CCO No.	Suppl. No.	Contract No.	Contract Name	Federal Number(s)
3		PW 09 - 30446	Durock Road and Business Park Drive, Traffic Signal and Intersection Widening	None

**EL DORADO COUNTY DEPARTMENT OF TRANSPORTATION
CONTRACT CHANGE ORDER MEMORANDUM**

Subject:	Unstable Subgrade	Date:	November 18, 2010
Client:	County of El Dorado		
Project:	Durock Road	Project No:	151097
By:	Christopher D. Trumbull, P.E., G.E.

DUROCK ROAD & BUSINESS DRIVE
TRAFFIC SIGNAL & INTERSECTION WIDENING
STA 473+00 IMPROVEMENT PLAN

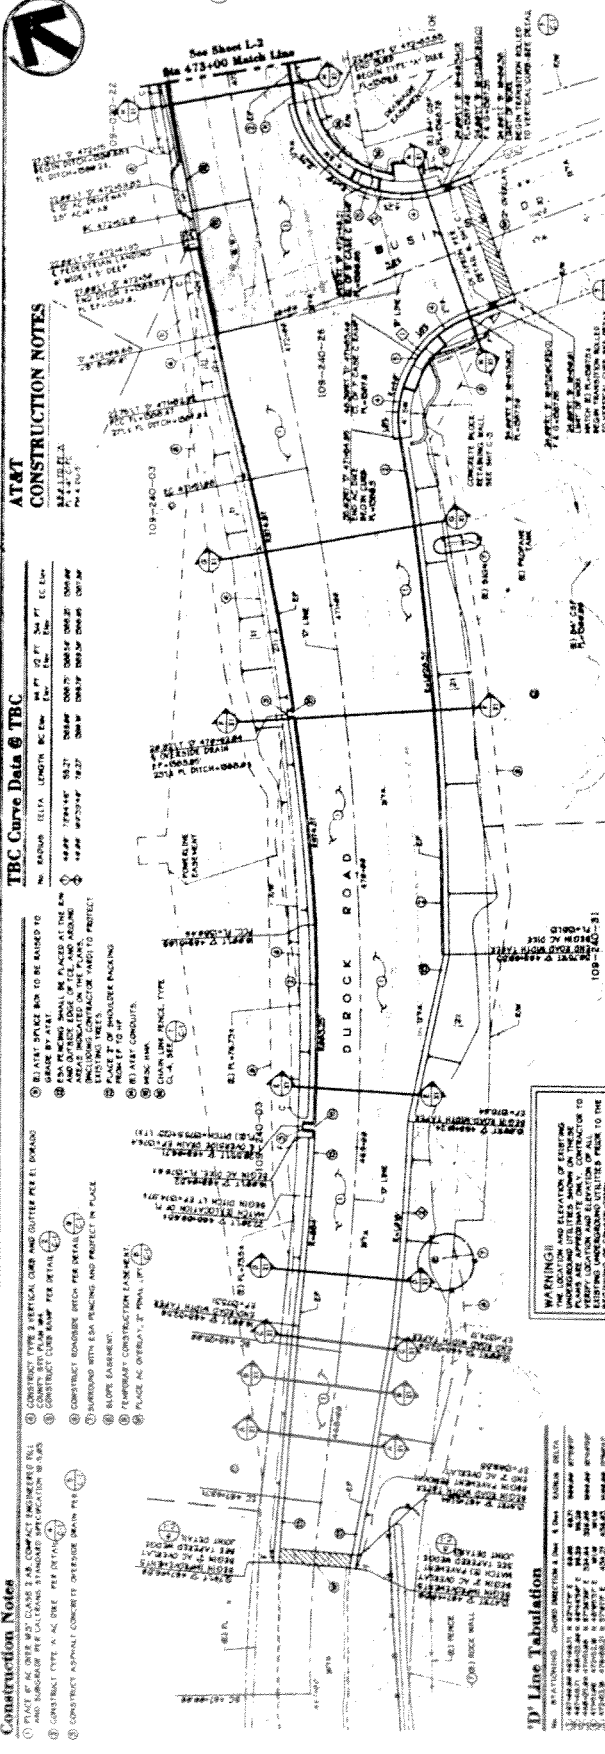
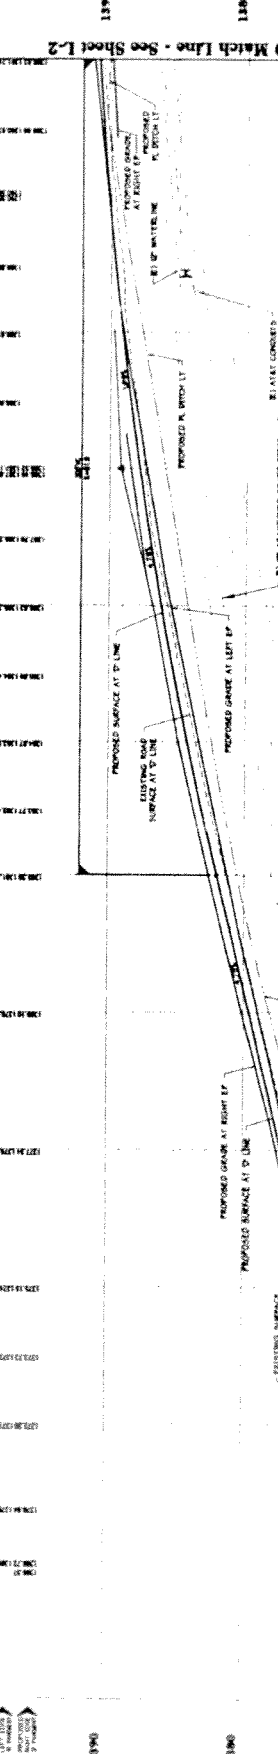
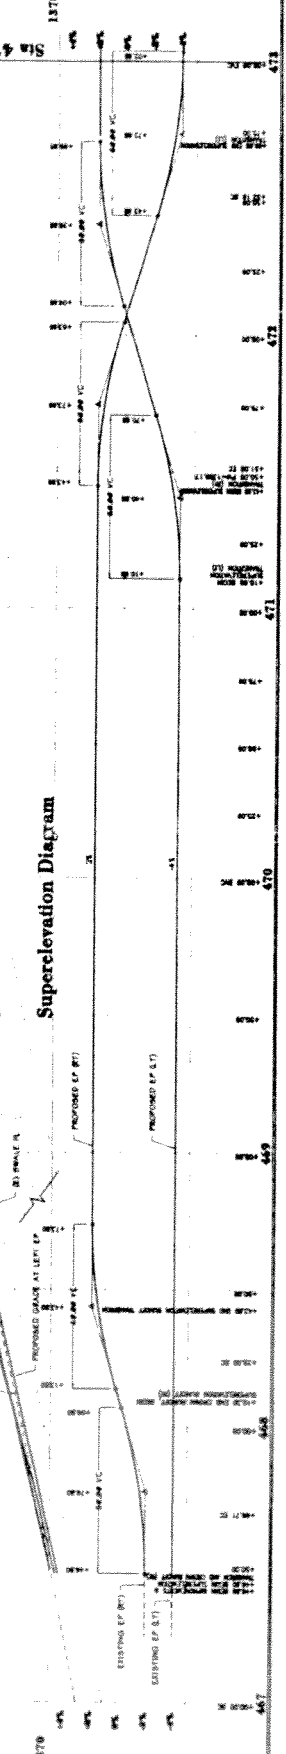
Change Required: This contract change order provides for the removal of unsuitable sub grade on the exposed contract work on Durock Road from Business Park Drive and east to Sta 475+50 (See Exhibit A). Note that as stage construction progresses, more unsuitable material could be found. The intent of this change order is to pay for the remediation of unsuitable sub grade that we have exposed to date in Stage 1.

During removal of the existing roadway, the Resident Engineer noted pumping over a significant portion of the newly exposed sub grade on eastern Durock Road when proof-rolled by a loader. A Geotechnical Engineer reviewed the area and recommended (See Attachment A) two options for remediation. The first option was to over excavate 18" below sub grade, place stabilization fabric (Mirafi 600x or similar), and backfill to design sub grade with aggregate base. The second option was to over excavate 9" below sub grade, place geogrid (Tensar BX1200 or equivalent), and backfill with aggregate base to design sub grade.

Where the Engineer determines that the subgrade for the work on this contract is unsuitable, the Contractor will be directed to perform the work per the Geotechnical Memorandum dated November 18, 2010, Option 2, by Chris Trumbull (Attachment A). Additionally, the Engineer may direct the Contractor to modify the dig out depth or Geogrid placement based on actual field conditions.

Exhibit A CCO #4 and ~~CCO #5~~

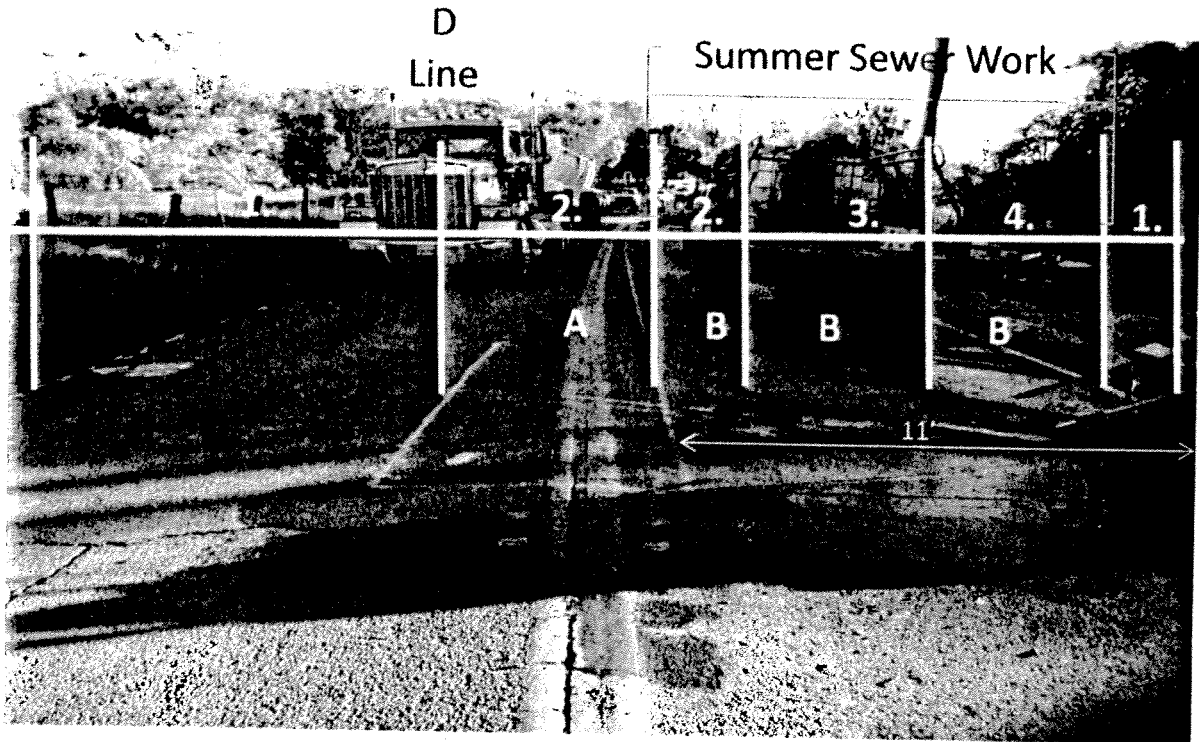
This change order was requested by the DOT Design Engineer in order to provide a more uniform roadway structural section. Per the project plans, the cross section on this roadway would have four different structural sections (see Exhibit A) which would make the roadway subject to variable stress cracking and reduced lifespan. Additionally, based on our observation on the CCO#3 dig outs, there is suspected unsuitable "pumping" soil in this section of roadway that, if left in place, could further compromise the life of the roadway and add additional variable stress cracking in the pavement structure.

By removing and replacing the current eastbound roadway in its entirety, and providing the ability to mitigate any unsuitable pumping soils that may be found, the completed roadway will have a uniform structural section and potentially a longer service life.

The Contractor is directed to perform additional roadway removal and replacement for the remaining 11-foot section of roadway from D Line Sta 473+23 to Sta 475+50 (See Attachment B for CCO area). The replaced roadway structural section is to conform to the contract document typical roadway section of 10.5-inch Aggregate Base with 6-inch Asphalt Concrete

1. Remove and replace per Project Plans
2. Overlay old Lincoln Hwy
3. Overlay trench section from Summer Sewer Work
4. Overlay old Durock (no old Lincoln Hwy here)
- A. Remove and replace per CCO #5
- B. Remove and replace per CCO #4

DUROCK ROAD STA 473+00 TO STA 478+00 DEMOLITION PLAN

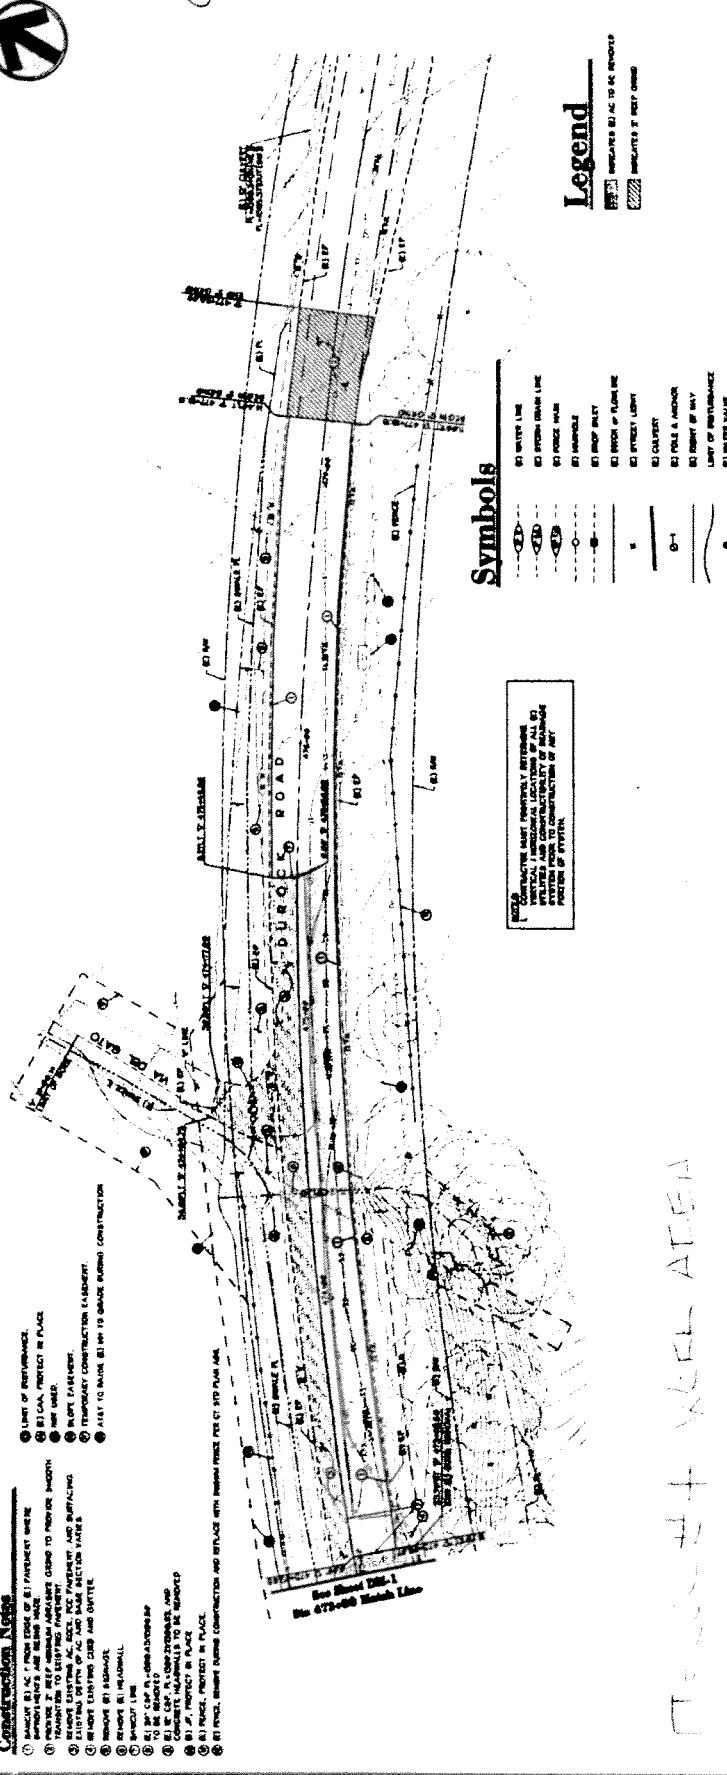
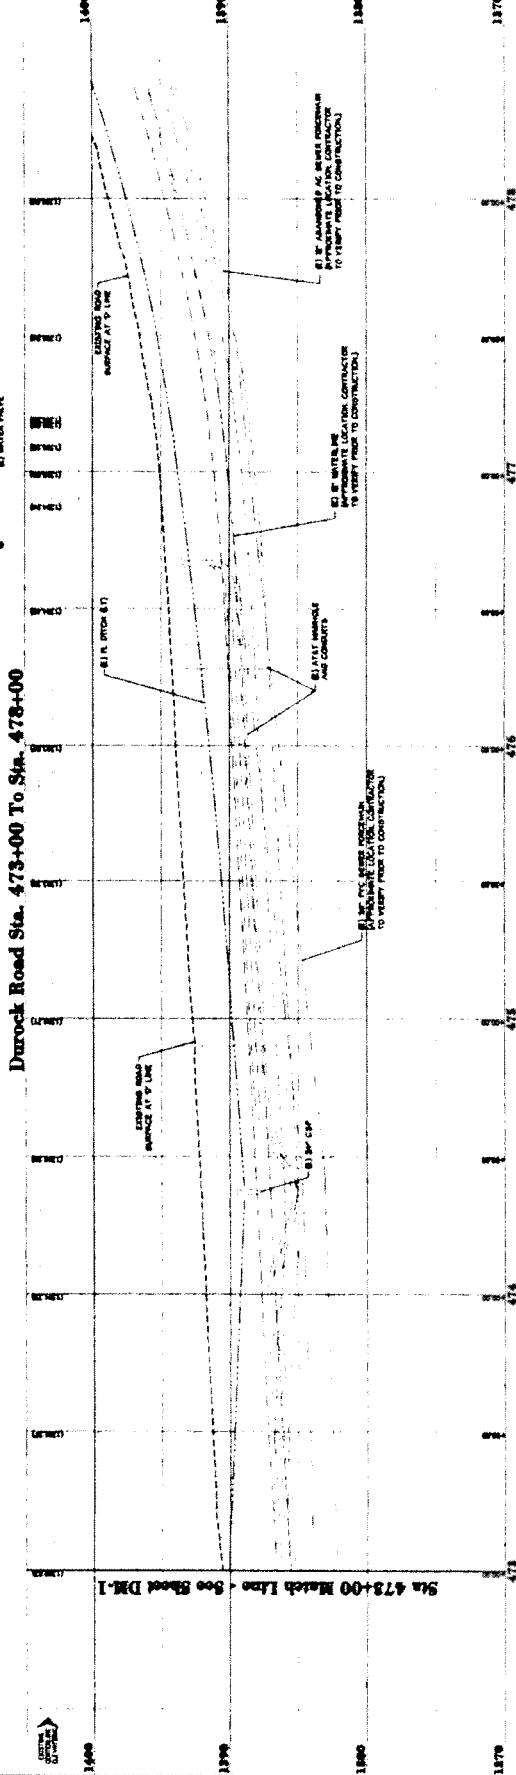
Change Required: This contract change order is for additional roadway removal and replacement for the remaining 11-foot section of roadway from D Line Sta 473+23 to Sta 475+50 on Durock Road.

Exhibit A ~~CCO #4 and CCO #5~~

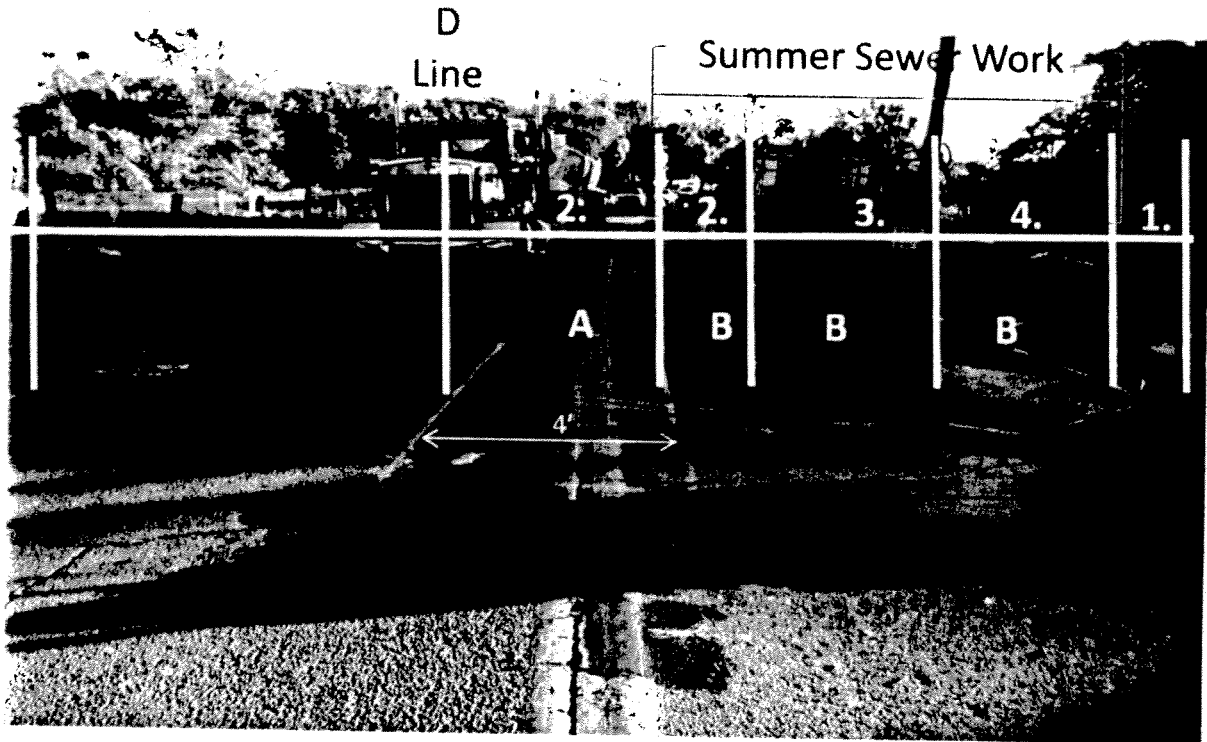
Change Required: This contract change order is for additional roadway removal and replacement for a 4-foot section of roadway from "D" Line Sta 473+03 to Sta 475+50 (Refer to "A" on Exhibit A, attached) and an adjacent 11' x 20' area, on Durock Road.

This change order was initiated by the Resident Engineer (RE) based on the reflective cracking of the 4-foot wide existing roadway section ("A" on Exhibit A) that was to remain in place. This 4-foot section ("A" on Exhibit A) was sandwiched between the "D" Line and just south of the existing centerline of Durock Road. The contract documents at the above stations show the existing roadway to the left of the "D" Line to be replaced. To the right of the existing Durock centerline, the roadway was partially improved with the 24-inch sewer line placed by Teichert last summer (Refer to "B" on Exhibit A). Note that Exhibit A photo shows the 4' section with cracking (refer to "A"). Additionally, the 4-foot section also contains a portion of the old Lincoln Highway. This work was completed under written direction to the contractor with a forthcoming CCO as the RE's addressing the roadway removal layout was timely. The removal of the 4-foot section also conforms to DOT Designs' need to replace the entire roadway at this location for a more efficient design and longer roadway service life (refer to CCO#4).

Note the RE made this decision based on the information available at the time, which was that the structural section to the right of the existing Durock CL (Refer to "B" on Exhibit A) was removed and replaced during the 24" sewer line work last summer. It was later discovered that a portion of the old Lincoln Highway had been left in place by the sewer work in the "B" areas Shown on Exhibit A.

The Contractor is directed to perform additional roadway removal and replacement for a 4' section of roadway from D Line Sta 473+03 to Sta 475+50, and on a 11' x 20' area, as shown on the Attachment A. The replaced roadway structural section is to conform to the contract document typical roadway section of 10.5" Aggregate Base with 6" Asphalt Concrete.

1. Remove and replace per Project Plans
2. Overlay old Lincoln Hwy
3. Overlay trench section from Summer Sewer Work
4. Overlay old Durock (no old Lincoln Hwy here)
- A. Remove and replace per CCO #5
- B. Remove and replace per CCO #4
